Thor Motor Coach Technical Service Bulletin

TSB #	TSB 22-01		
Description/Title:	Aria / Palazzo / Tuscany / Venetian Inverter		
Affected Product Line(s):	Certain model year 2022 Aria / Palazzo / Tuscany / Venetian motorhomes		
Service Campaign # :	RC000251	Released Date:	2/7/2022
Codes:	Inspect Only: TMCTS80271Y Repair: TMCTS80271W	Document Date:	2/7/2022
Time Allowed:	Inspect Only: 0.1 Repair: 0.2	Document Revision:	A

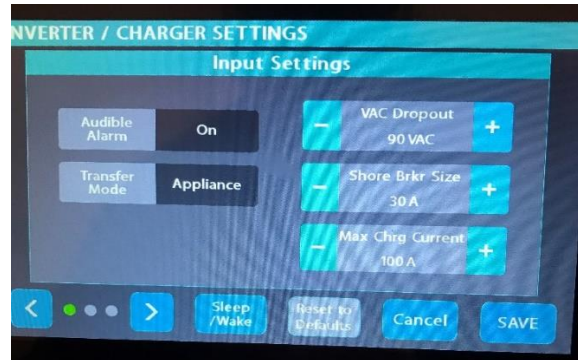
1. To begin, look at the inverter in the coach.
 - a. If the inverter is white, the coach has a Magnum inverter installed.
 - b. If the inverter is grey, the coach has a Xantrax inverter installed.
2. Next, go to the Firefly control panel.
3. Touch the lightning bolt on the left.
4. Touch the bottom right inverter/charger tab.
